BOARD OF COUNTY COMMISSIONERS
ORANGE COUNTY, FLORIDA

ADDENDUM NO. 3 / IFB NO. Y18-758-TA

SOUTH SERVICE AREA/EAST SERVICE AREA (SSA/ESA) 36-INCH POTABLE
WATER MAIN, 24-INCH RECLAIMED WATER MAIN AND J. LAWSON BLVD
POTABLE WATER RE-PUMP FACILITY

SCALE: AS SHOWN
 DRAWING NO.: **E-04**
 SHEET: 161 OF 292

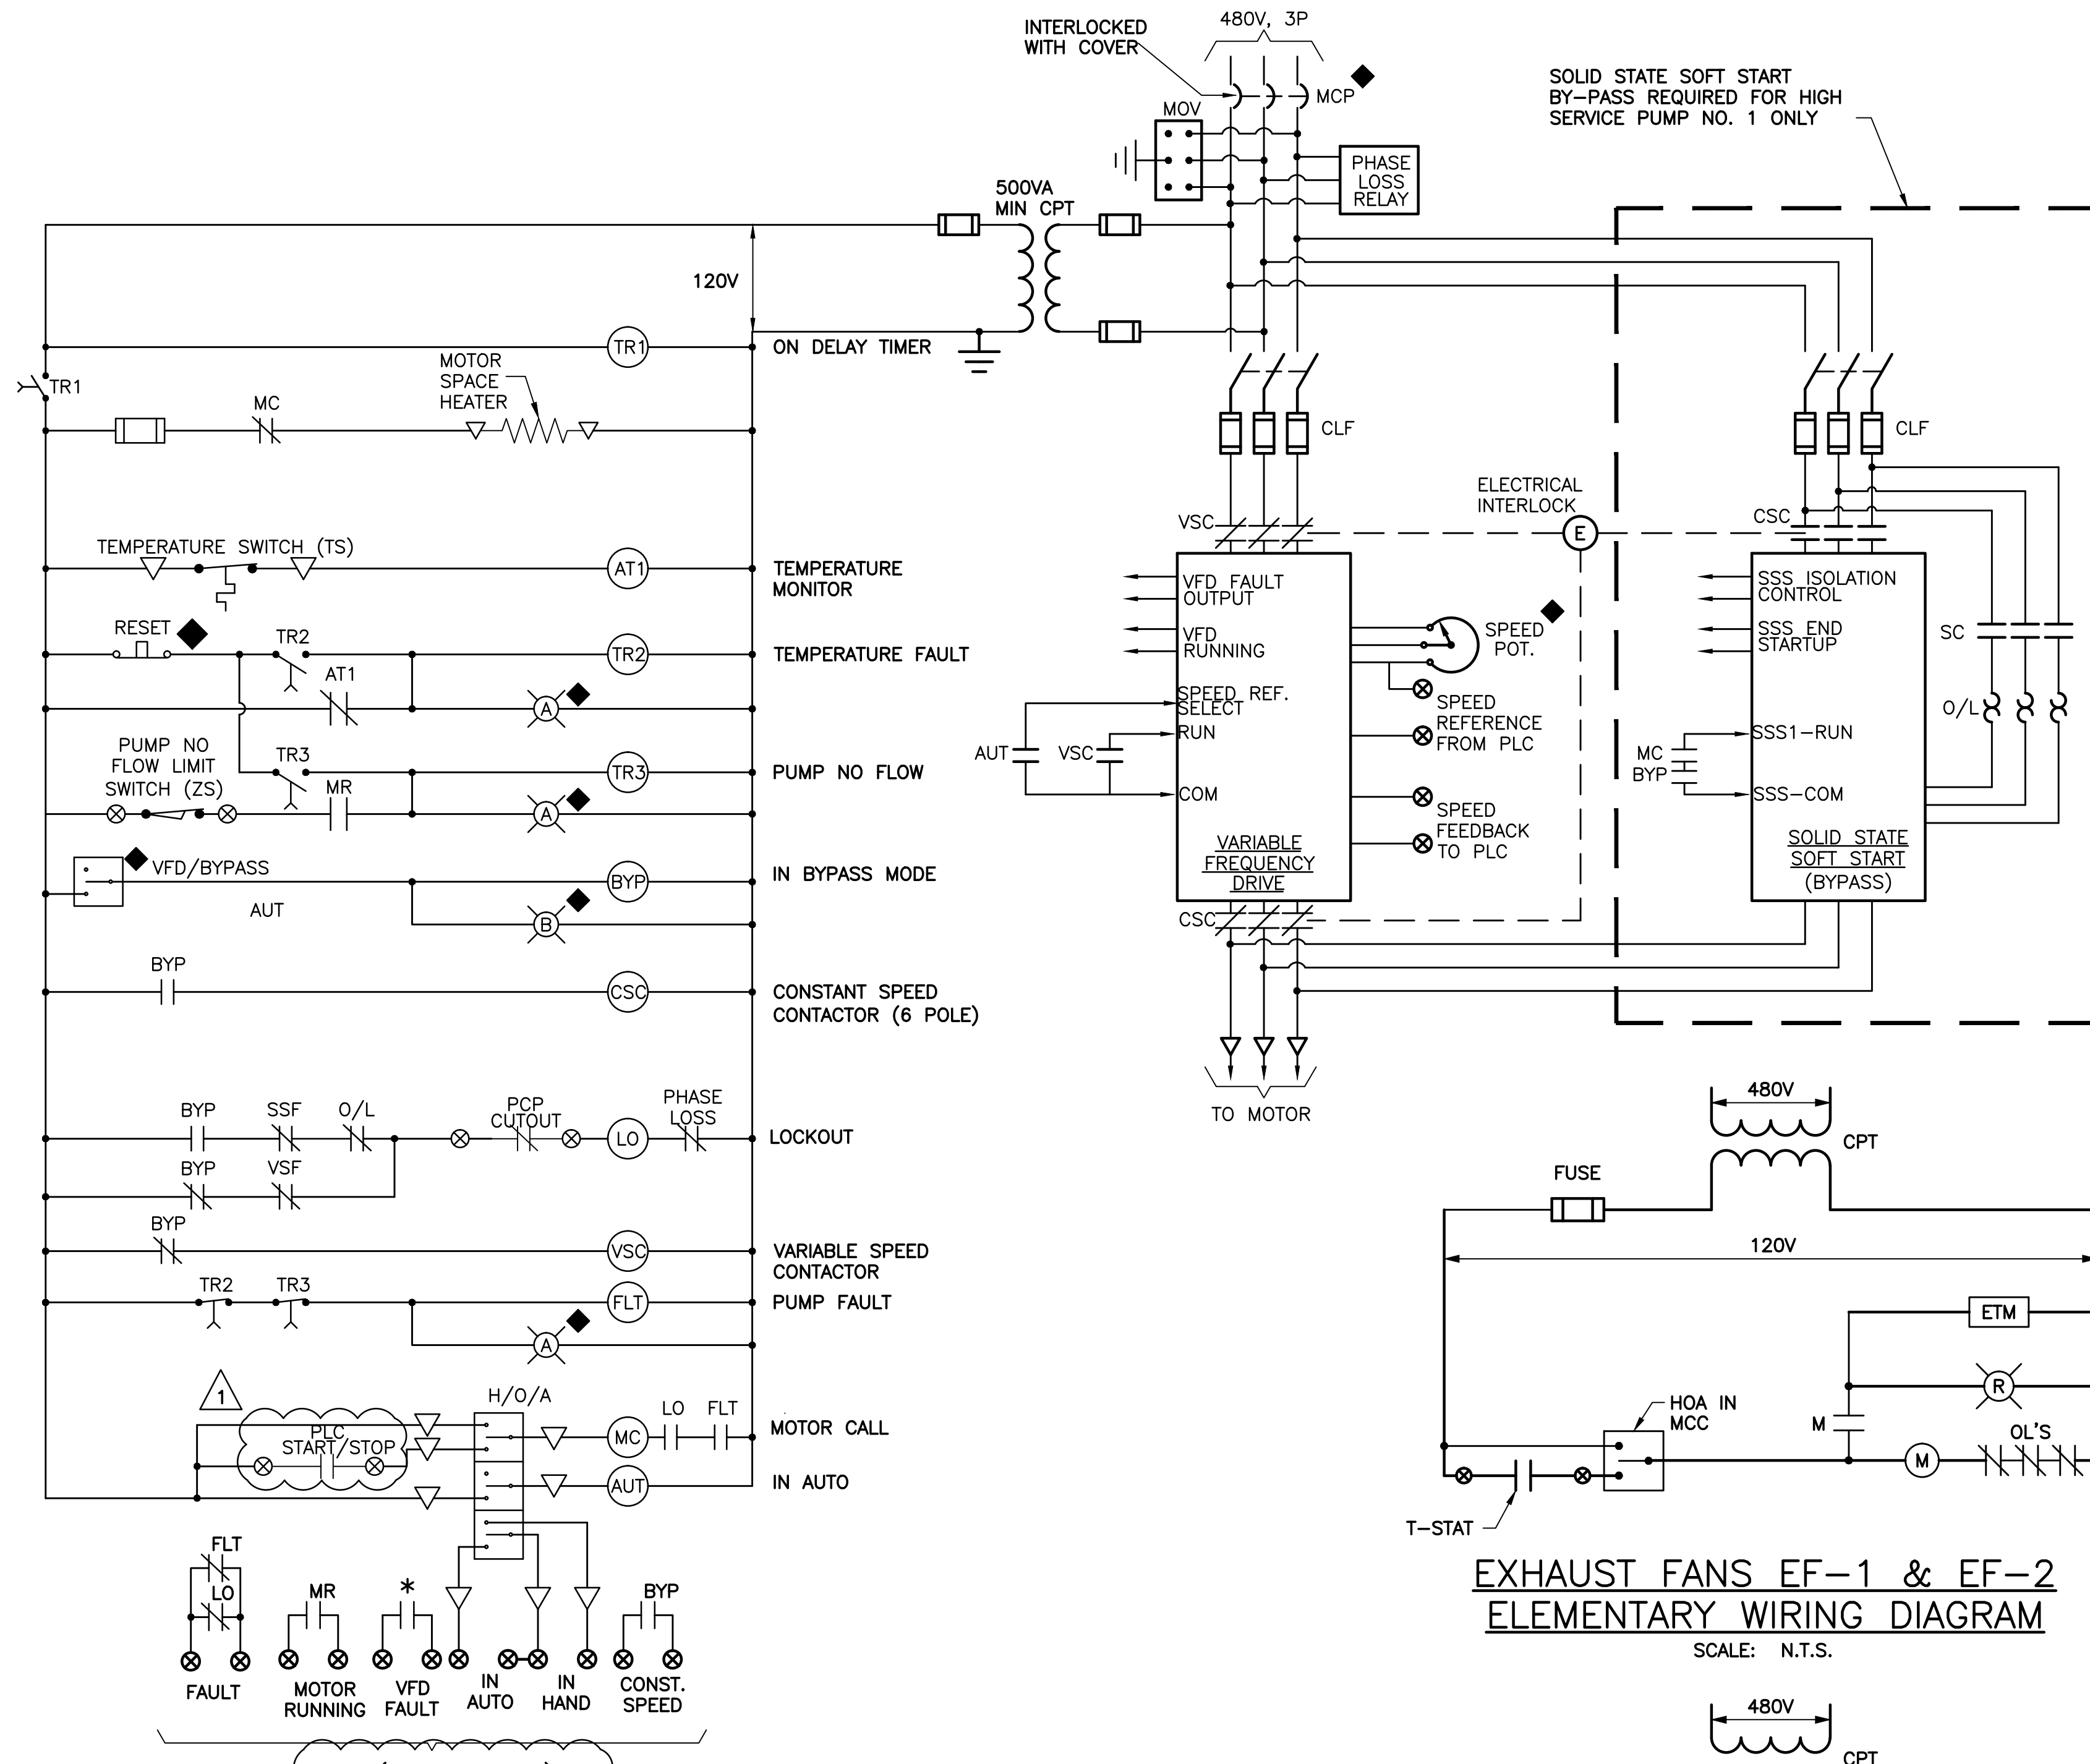
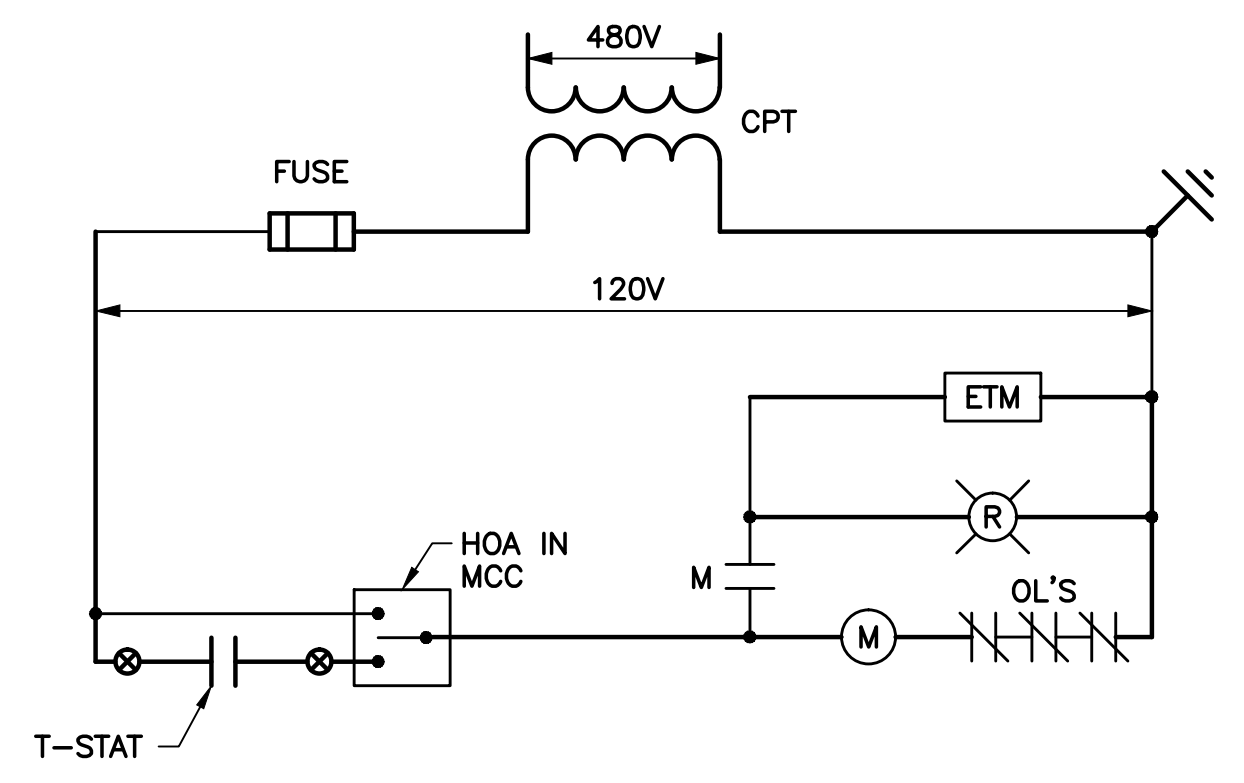
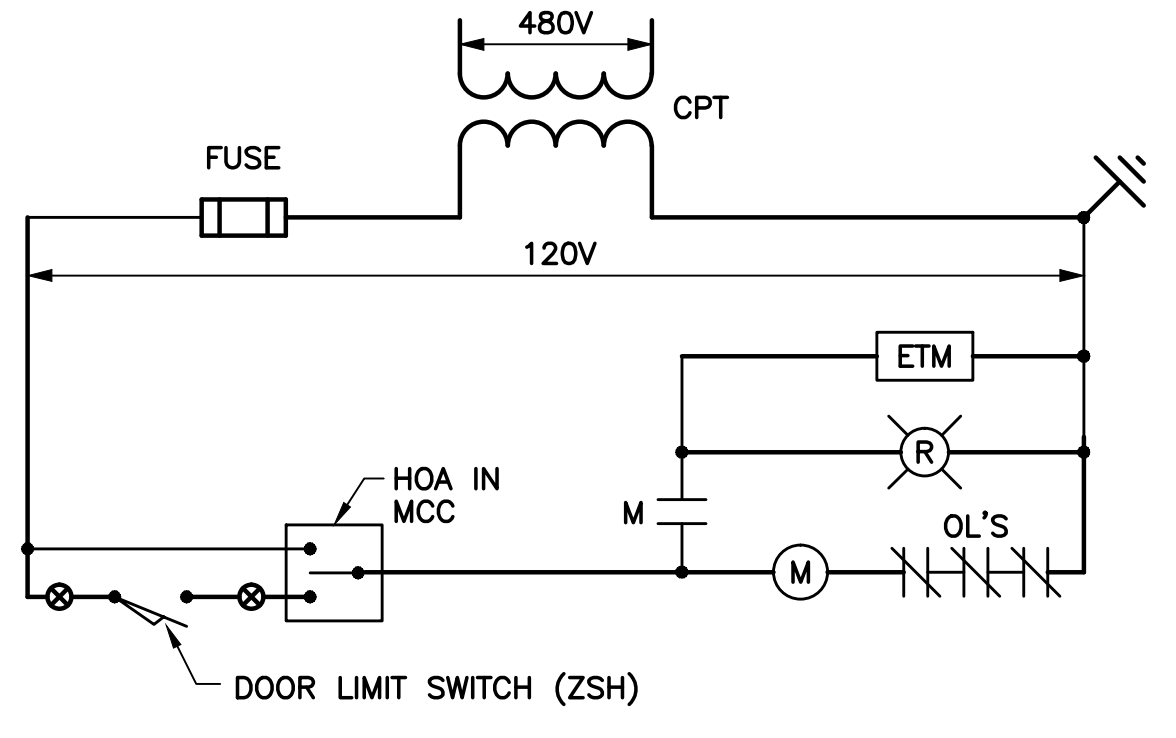
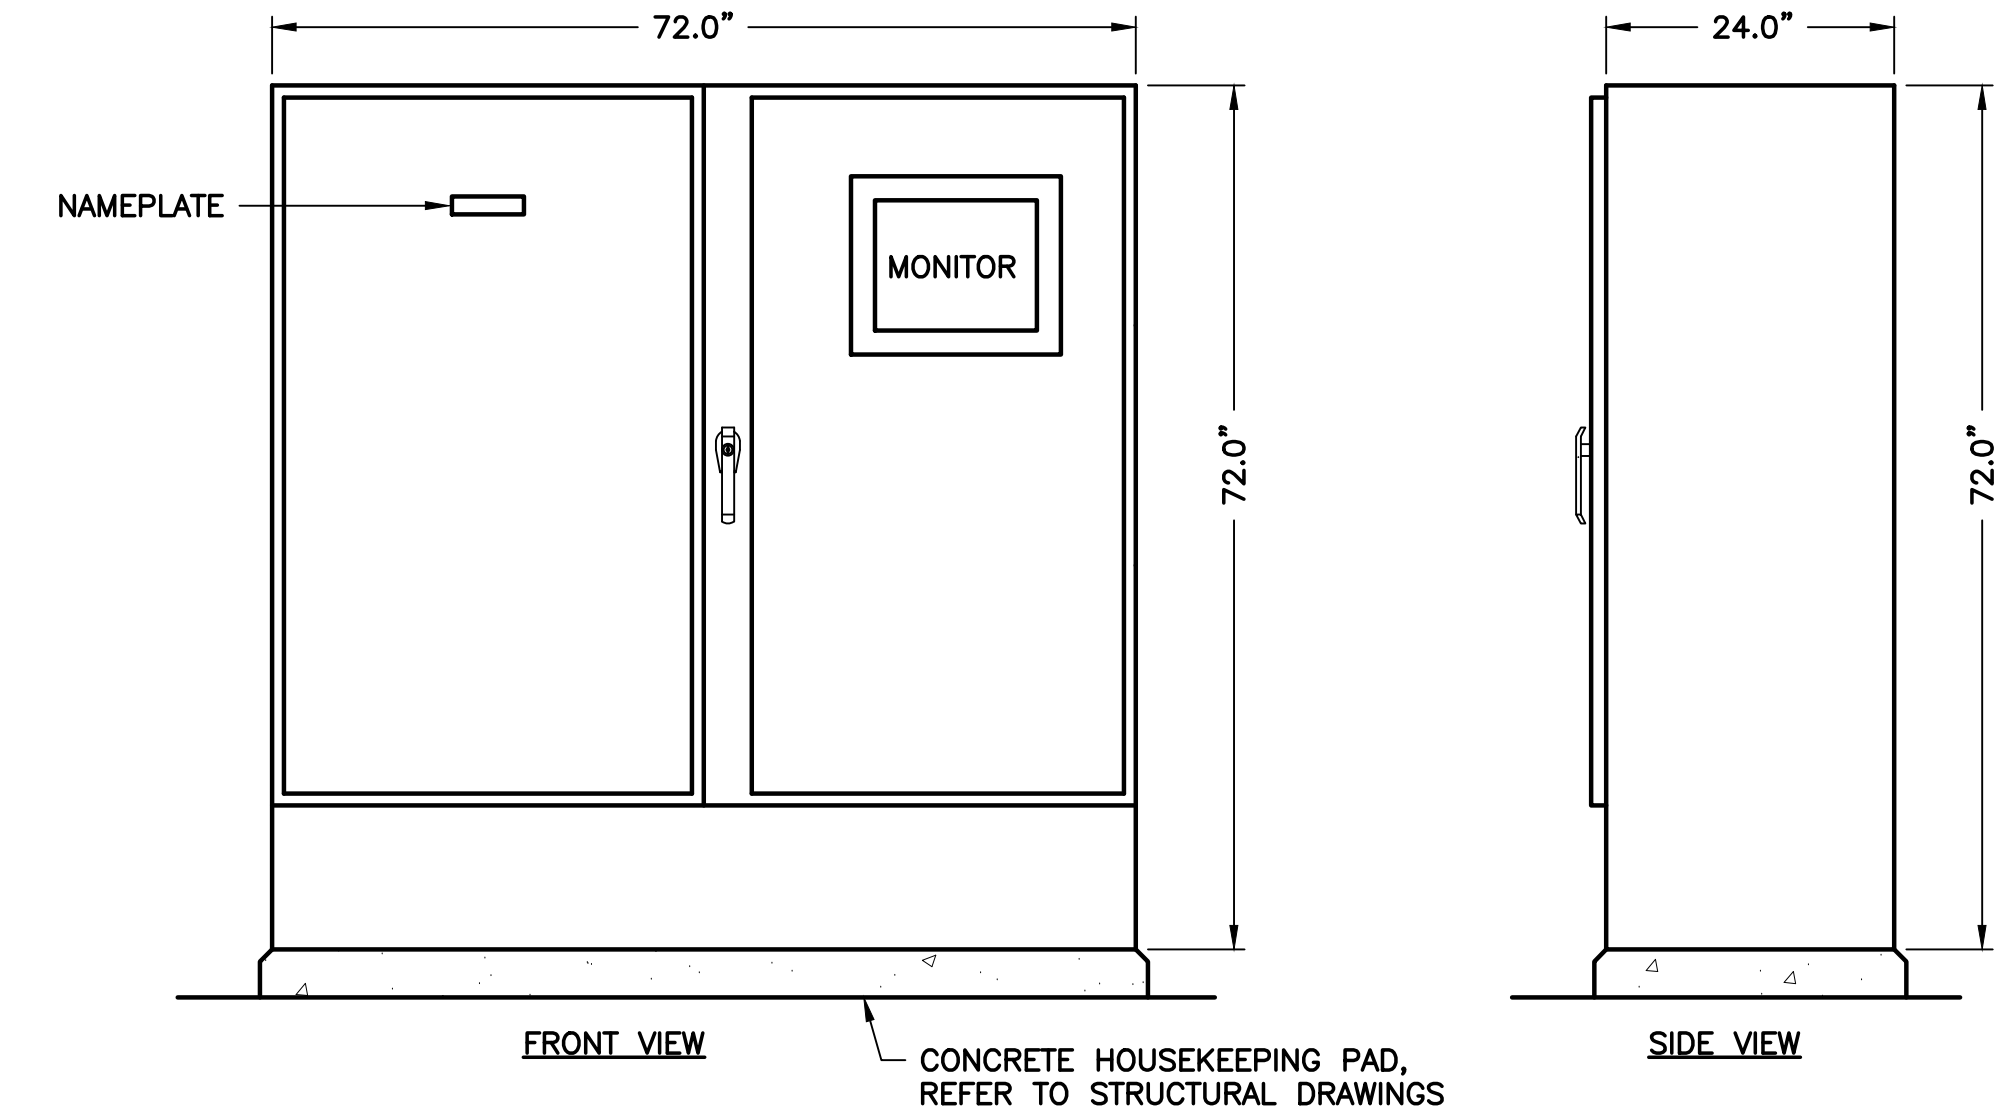
9. Q: I-02 show the VFD I/O being transmitted via Ethernet whereas E-05 shows a hardwire connection; please clarify which is to be used.

DRAWINGS E-04, E-05, and I-02

A: VFD I/O to be transmitted via Ethernet except the Pump start/stop (control) which is to be hardwired. See revised drawings E-04, E-05, and I-02.

Amend: Delete drawings E-04, E-05, and I-02 and replace with the revised Drawings E-04, E-05, and I-02. The revised drawings show the VFD I/O to be transmitted via Ethernet and the Pump start/stop (control) being hardwired.
